# **TELOPEA CONCEPT PLAN AND STAGE 1A**

SSD-14378717  
Response to RFI

Prepared for  
**FRASERS PROPERTY TELOPEA DEVELOPER PTY LTD**  
September 2023

Figure 2 Proposed height of buildings within the Core Precinct overlayed with LEP height controls (RtS Scheme)

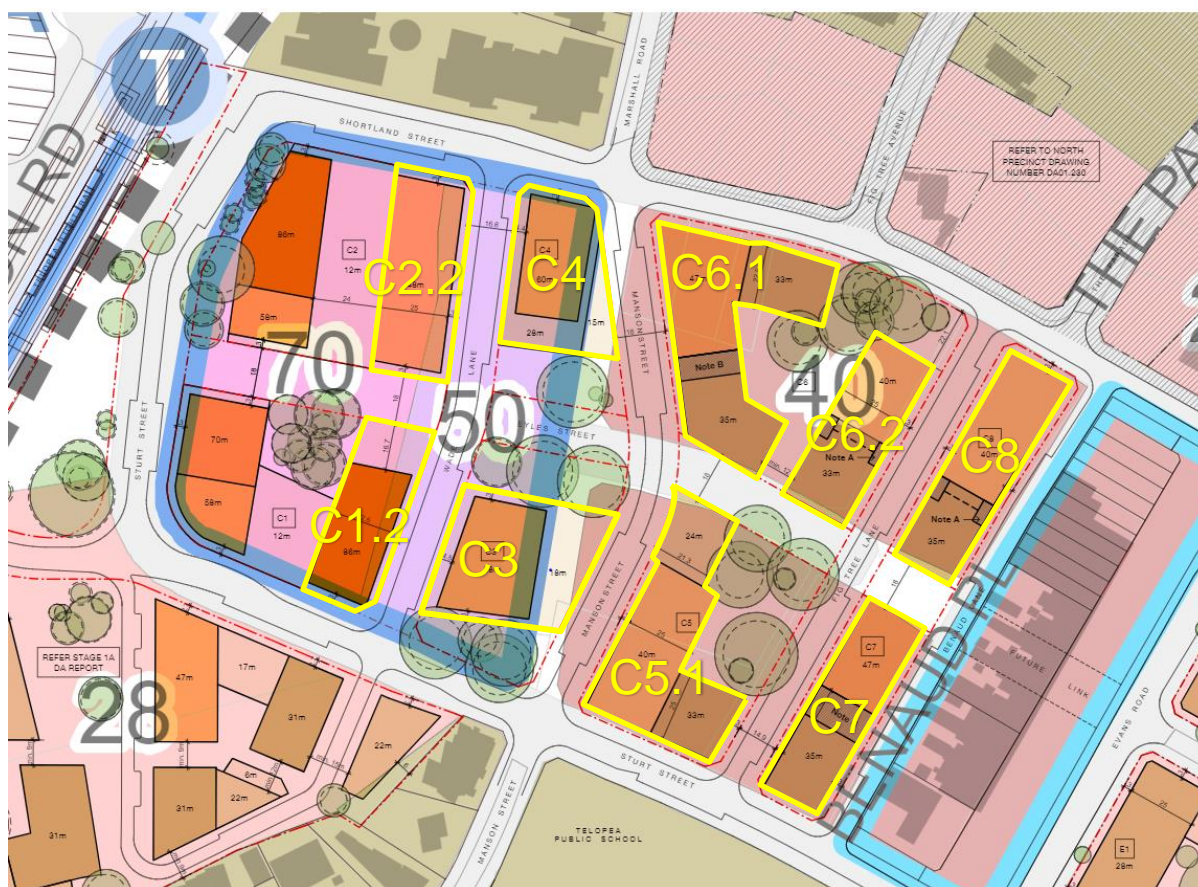
<p><u>Height</u></p> <p>Provide an updated Clause 4.6 variation request that correctly identifies the height limits identified in the Parramatta Local Environmental Plan 2011, noting that some building envelopes (C1 and C2) are located within the boundaries of two height controls and some building envelopes (C3 to C8) are located outside of the boundaries on the PLEP 2011 Height of Building Map. Provide further justification for any of the above height variations.</p>	<p>As noted in <b>Section 2.3.1</b>, it is acknowledged that buildings within the Core Precinct are partially located over multiple Height of Building standards on the Height of Building Map in the PLEP. While there are no changes to the overall building form or the location of non-compliant built form, the Clause 4.6 Variation for Height has been refined to clarify the non-compliances (refer to <b>Appendix T</b>). Further justification for the variation is also provided in <b>Section 2.3.1</b> of this report.</p> <p>It is also acknowledged that parts of C3 to C8 remain outside of an applicable height control due to the land swap associated with the road layout. As such, no height control applies to these areas therefore there is no non-compliance with the controls associated with these portions of the site. Nevertheless, for abundance of caution the CI 4.6 has been updated to address these buildings.</p>

It is also acknowledged that several buildings within the Core Precinct sit over two height controls identified in the PLEP. This is illustrated in **Figure 2** which was provided as part of the current Clause 4.6 variation for height in the Core Precinct. Parts of Blocks C3 to C8 remain outside of an applicable height control due to the land swap associated with the road layout. As such, no height control applies to these areas therefore there is no non-compliance with the controls associated with these portions of the site.

While there are no changes to the proposed overall height as part of the refinements described above, the Clause 4.6 Variation for height has been refined to clarify both the split controls and where no height control applies. A summary of the proposed height of buildings variation is provided in the table below with updates provided in [blue](#) and the amended Clause 4.6 Variation for Height (**Appendix T**).

The maximum building height is proposed to be exceeded on Blocks C1, C2, C3, C4, C6 and C7 (refer to **Table 4**), noting that Block C3 is a partial non-compliance only. Council's RTS response identified a 79% non-compliance within the Core Precinct. The greatest exceedance within the Core is 37 metres (74%) which is attributed to Building C1.2 which straddles the 50 and 70 metre height controls applicable under the Parramatta Local Environmental Plan 2011 (**PLEP**). Blocks C1 and C2 are both located within the Upper Core in immediate proximity to PLR where the tallest buildings are located, and accordingly the height reflects the sound planning principle to locate highest densities closest to public transport and amenities.

The degree of variation is either reduced and/or offset by lower building heights the further the development transitions eastward from the Middle Core to the Lower Core. Most notably, eleven buildings within development blocks C5, C6, C7 and C8 (east of Manson Street in the Middle and Lower Core), maintain a compliant or reduced height.

Figure 6 Building Separation – Building A to Building B

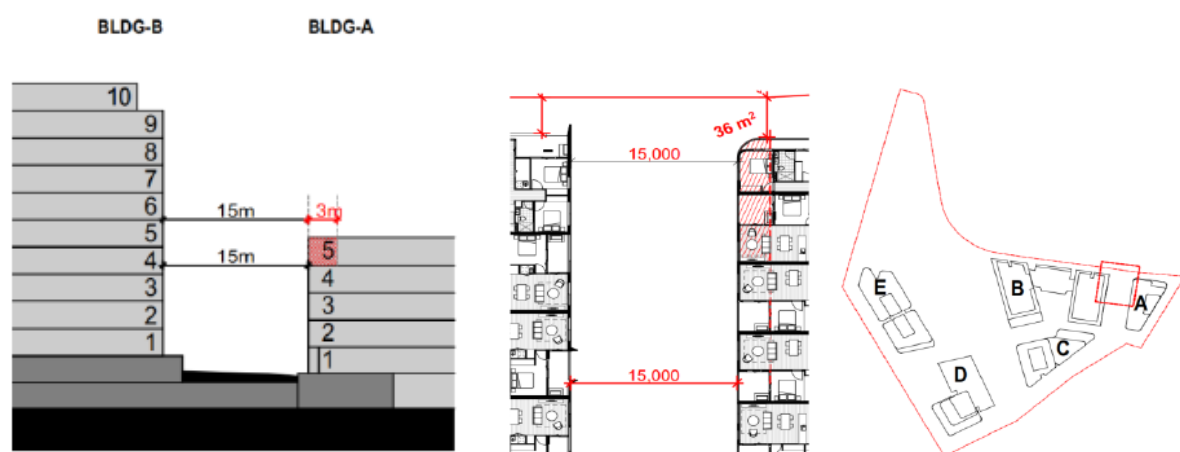
<p>Outline how the Stage 1A proposal complies with the building separation design criteria in the ADG for the proposed buildings and neighbouring properties and provide justification / amendments to address any non-compliances.</p>	<p>Building by building ADG compliance tables have been prepared by Plus Architecture for Stage 1A and are enclosed in <b>Appendix A</b>.</p> <p>A summary of how the development meets the relevant building separation criteria is provided below in <b>Section 2.3</b> of this report.</p>

A 15 metre building separation has been proposed between Building A and Building B providing 3 additional metres of separation than required by the ADG for development up to four storeys. The identified non-compliance directly relates to the fifth storey of Building A which results in a minor non-compliance of 3 metres along the western edge of Level 5 (refer to **Figure 6**). The identified non-compliance with the ADG is limited to a 13 metre zone, which equates to approximately 36sqm of floor space.

The affected apartment (A.02.04) is a corner unit which fronts Sturt Street and the internal loop road. Despite the numerical non-compliance, the living rooms and principal open spaces of both impacted apartments in Building A and Building B are oriented north to minimise overlooking and ensure direct lines of sight between buildings are avoided.
